Public Facilities Committee Agenda

#104-23 **Requesting update regarding Gath pool design**
COUNCILORS ALBRIGHT, KRINTZMAN, KELLEY, AND LEARY requesting an update from Commissioner Banks regarding the Gath pool design.

RE: New Gath Pool depth analysis

subject: Lap Pool Depth Study

P801

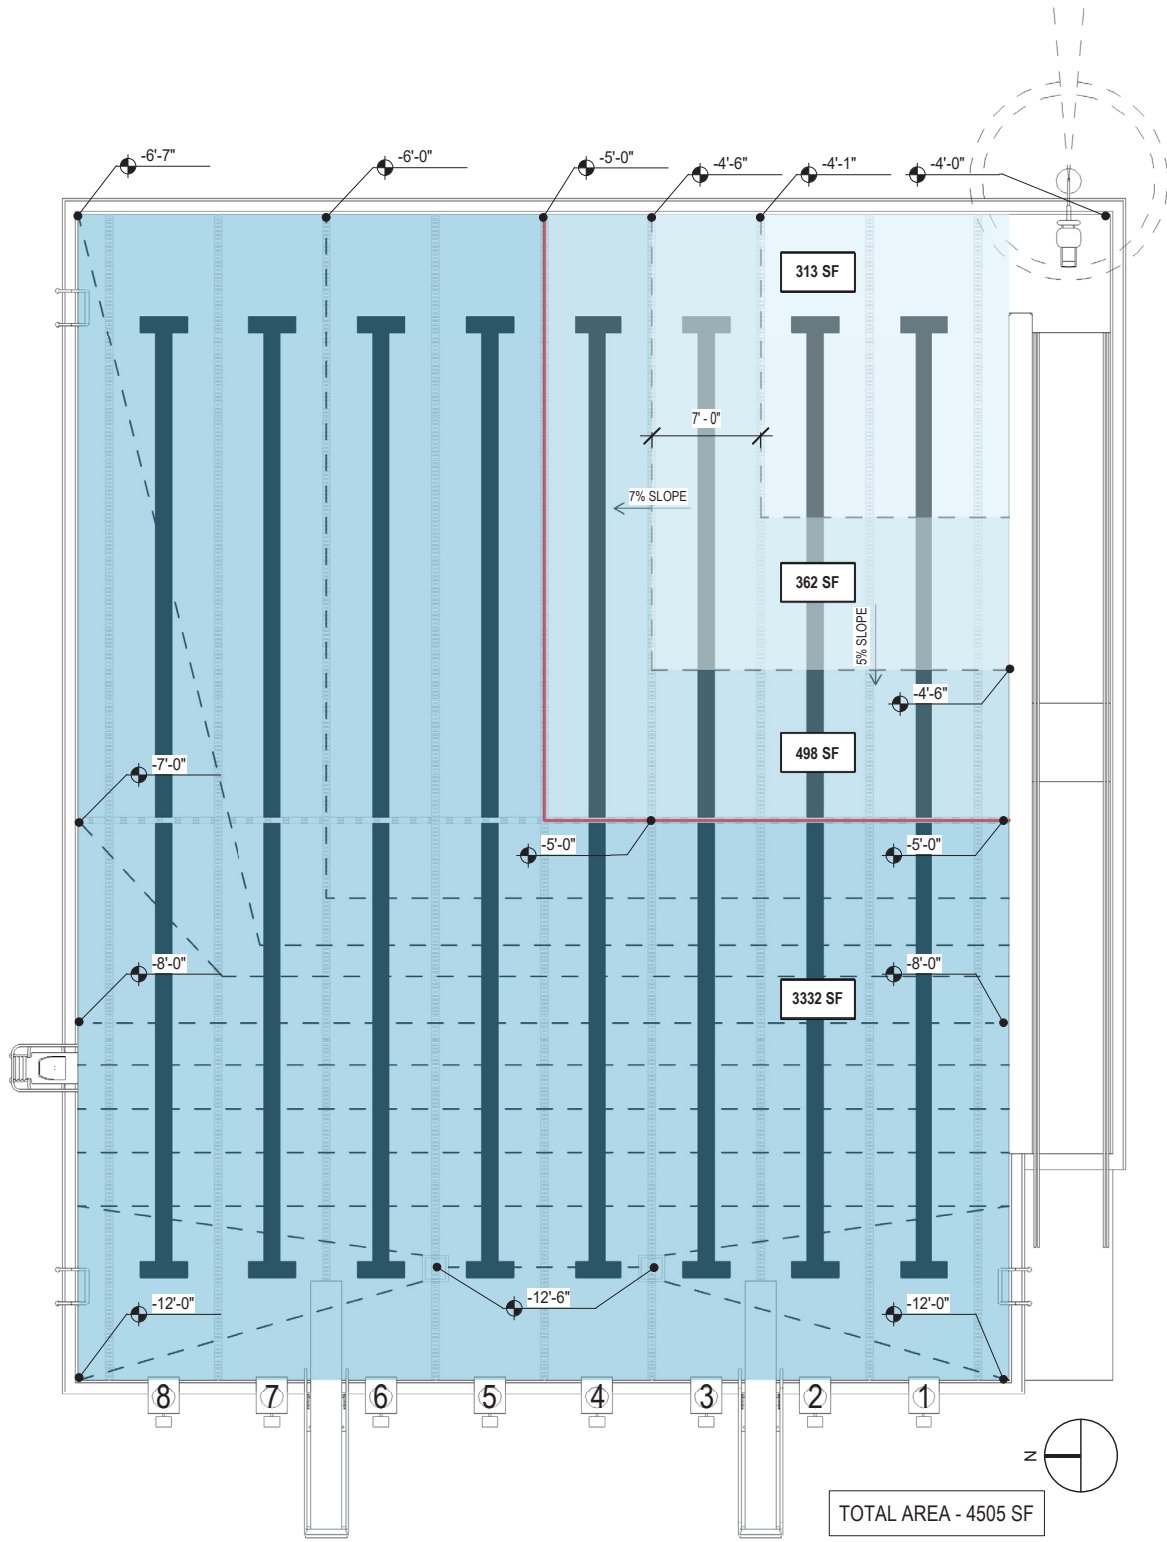
- The shallow wall along the entire length of the pool is 4ft.
- The first ten feet of pool floor slopes at 1%. This area shown shaded is 600 SF.
- The remainder of the non-swimming area slopes at 2%. This area is show with a diagonal cross hatch. The area is 1,745 SF.
- From the 5ft. depth, the pool slopes to 12 feet.
- The bottom of the pool has a continuous 12 ft. depth around the perimeter, the main drains are set at 12"-6" inches to ensure full drain down of the pool.
- The pool bottom and lane markers are uniform in all 8 lanes.

P801.1

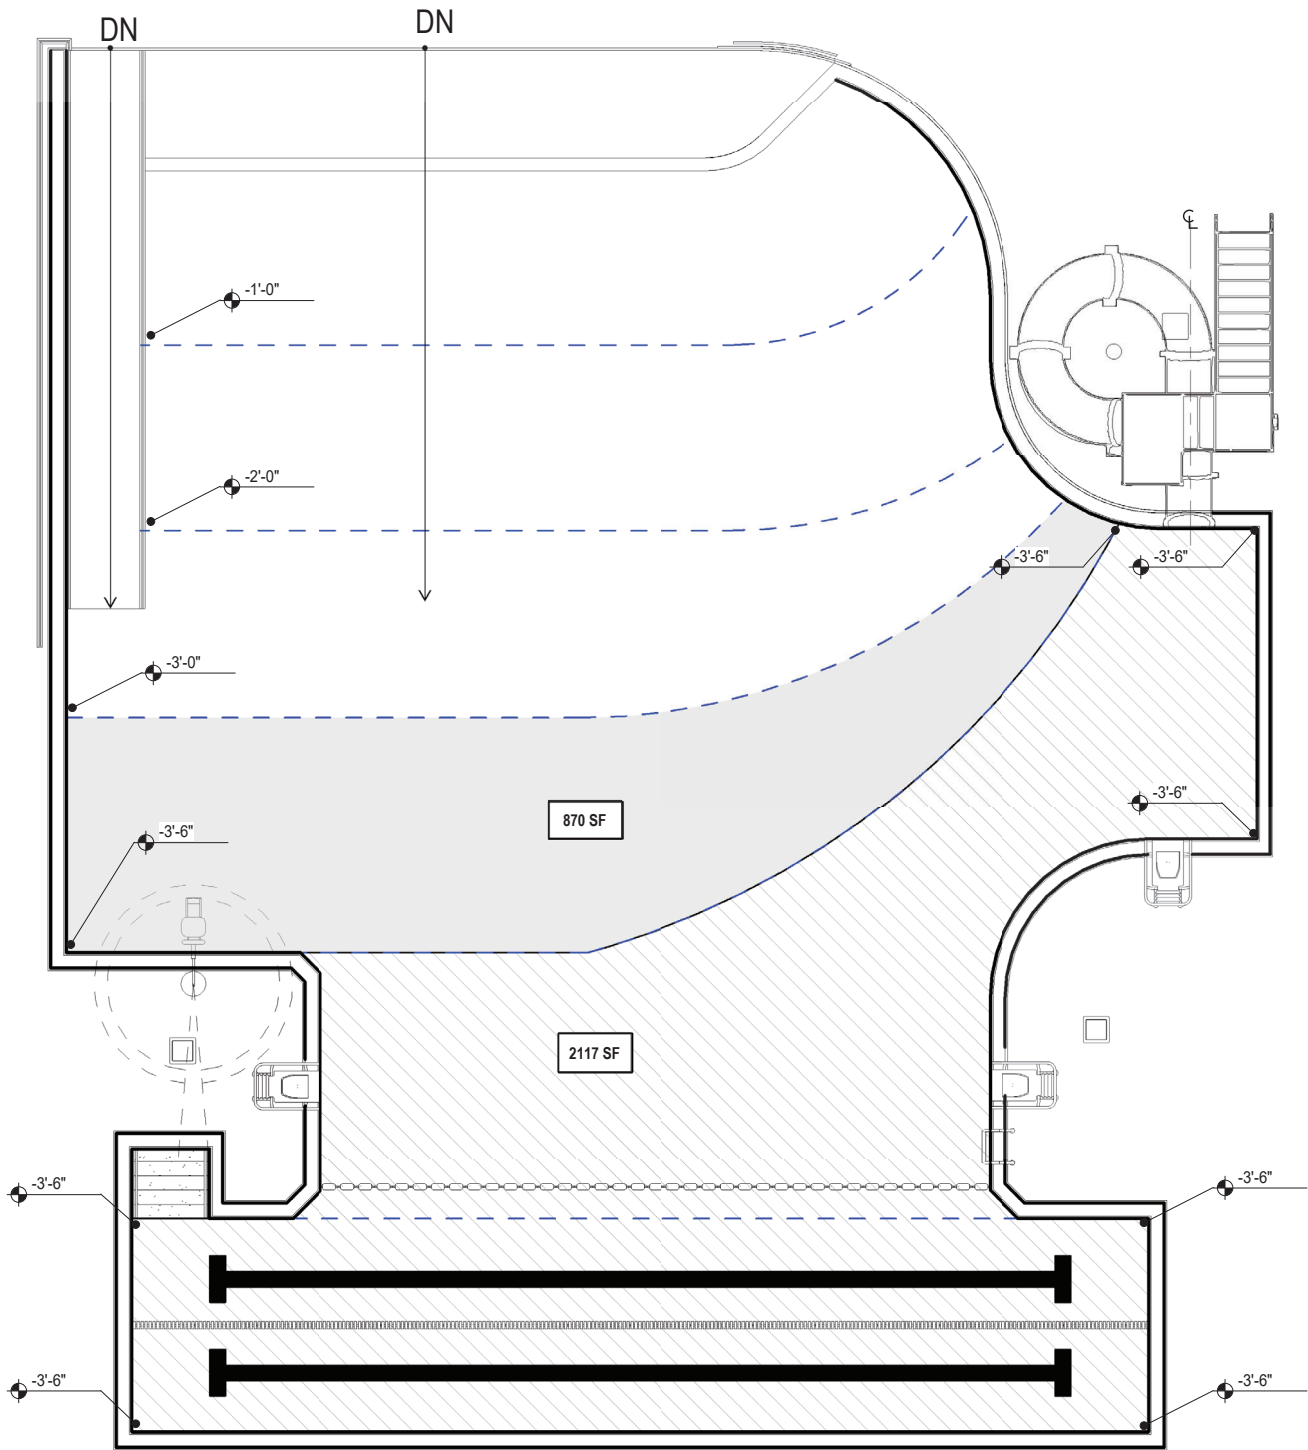
As requested, we have developed an option to increase the pool depth at the shallow end of the lap pool. The pool depth would be 4 feet at the entry side of the pool and descend to 6'-7" at the northeast corner.

- The shallow wall drops from 4 feet at lane 1 to 6'-7" at the northeast corner of lane 8.
- A 1% slope is maintained at the shallow end of lanes 1 and 2. The area shown shaded is 304 SF.
- The remainder of the non-swimming area slopes between 5 & 7%. This area is shown with a diagonal cross hatch. The area is 1,140 SF.
- Lanes 5 and 6 slope from 5 ft. to 6 ft.
- Lanes 7 and 8 slope from 6 ft. to 6'-7".
- The bottom of the pool has a continuous 12 ft. depth around the perimeter, the main drains are set at 12"-6" inches to ensure full drain down of the pool.
- The bottom tile lane markings are uniform in lanes 1 and 2; the markings in lanes 3 to 8 perpendicular to the floor bottom slope. The slope is shallow and the lane markers will be clearly visible to swimmers. This condition is typical in many swimming pools.
